LFHCAL Geometry: Simulation vs. Project

Peter Steinberg / 16 September 2025 / ePIC simulations

Longitudinal sizes

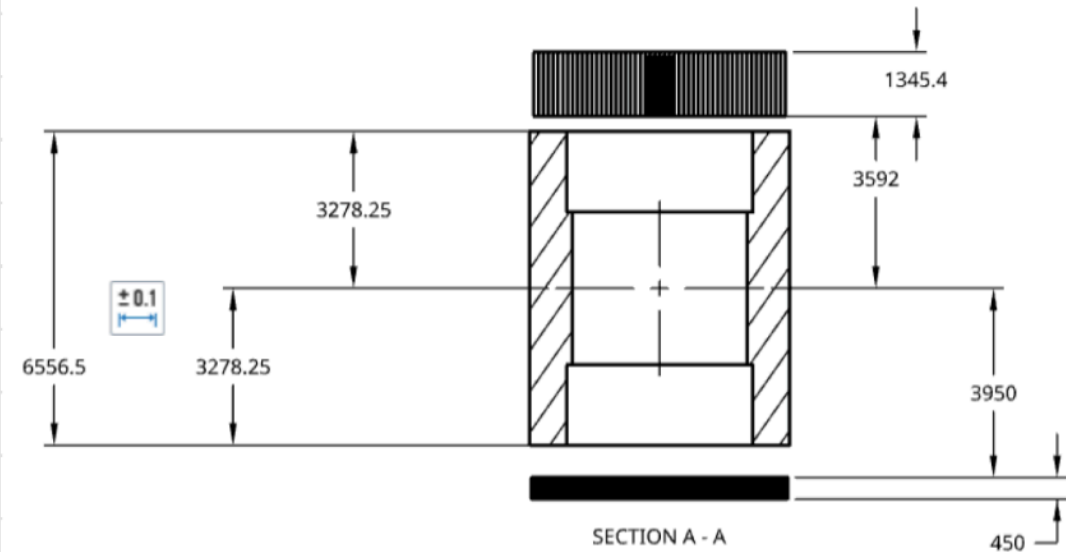
Project envelopes	25.08.0 simulation	Delta	Comments
Total 1/2 length	3645+1320=4,965	3592+1345=4,937	28	Project “longer” overall
LFHCal length	1320	1345	25	Geometry includes mounting plate
BHCal 1/2 length	3196.25	3278.25	82	Project missing dogbones?
LFHCal front	3645	3592	53	25.08 is “closer”
fEMCal gap	448.75	313.75	135	Envelope has larger gap

Project should keep overall longitudinal envelope, but 1) extend LFHCAL by 25.4 mm, accounting for mounting plate, 2) extend BHCal (after checking w/ DSC) to 3278.25, leaving 340mm gap for fEMCal

Simulation should move LFHCAL back by 28mm to agree with project envelope, leaving 341mm gap for fEMCal

Transverse sizes

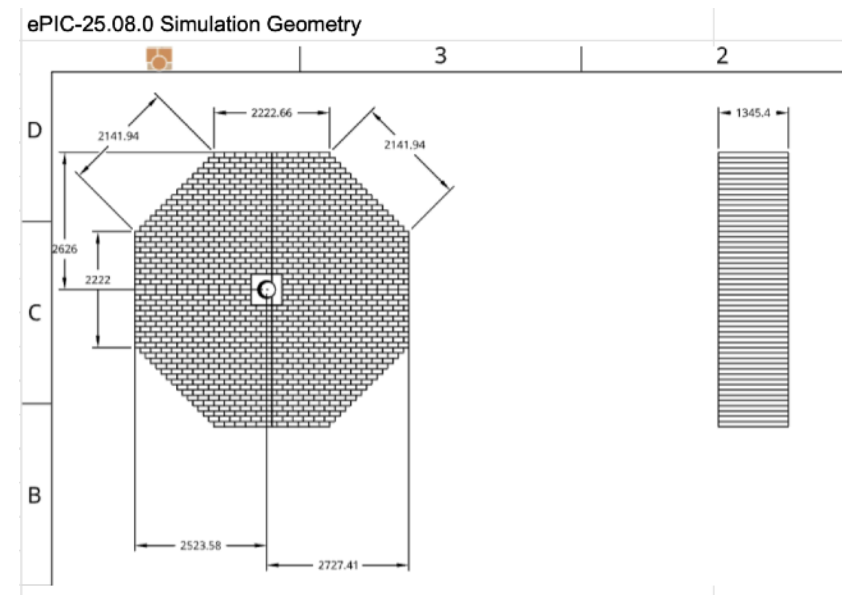
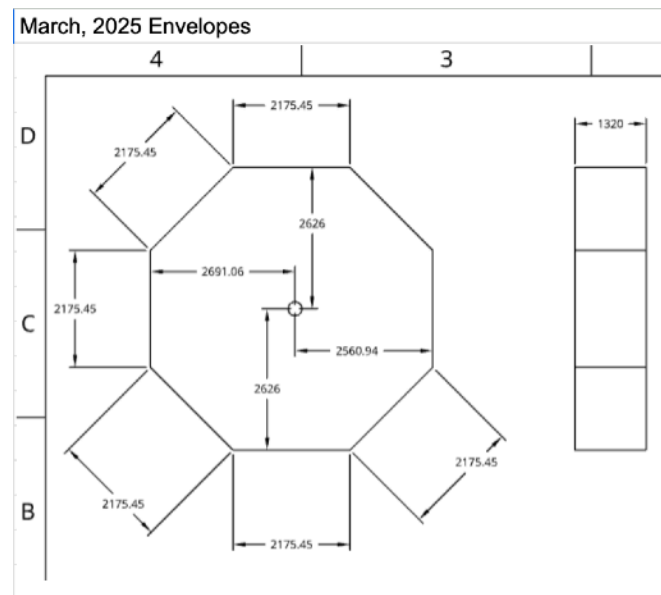
Total horizontal and vertical extent is $2626 \times 2 = 5,252$ mm (25.08 is shorter by 1mm horizontally in simulation)

Serious issue #1: based on position of hole, envelope perspective starts at interaction point ($z=0$):
+x is in negative direction!

Conversely: Simulation geometry is looking back at IP from positive z,
so positive x is in the positive direction

Serious issue #2: simulation geometry is made of 8M “bricks” which are 20x10cm+margin:

In vertical: $2222/22$ blocks = 101 mm, i.e. 10cm + 1mm margin (100+1 actual)

In horizontal direction: $2222.66/11 = 202.06$, i.e. 20cm + 2mm margin (reflecting original design & request for 2mm gap from project)

Conversely: March 25 envelope vertical distance is 2175.45, which is 46.55mm too short.

Horizontal distance is a similar issue. In both cases, module dimensions < actual

**NB: Discussions w/ LFHCAL management reveal that modules are 199mm wide, which needs to be fixed in sim,
But this is also not consistent with 2175.45 for 11 modules (198mm/module including gaps)**

One non-issue: Envelope distance of beam hole to closer edge is 2560.94 which looks 37.4mm “longer” than 2523.58

This is looking from opposite sides, so explained by 0.025 rad crossing angle over 1345.4mm = 33.6mm

**Proposal: simulation geometry is correct, up to 1mm reduction/module, and envelope should be
Revised to reflect the number of modules and the module width**
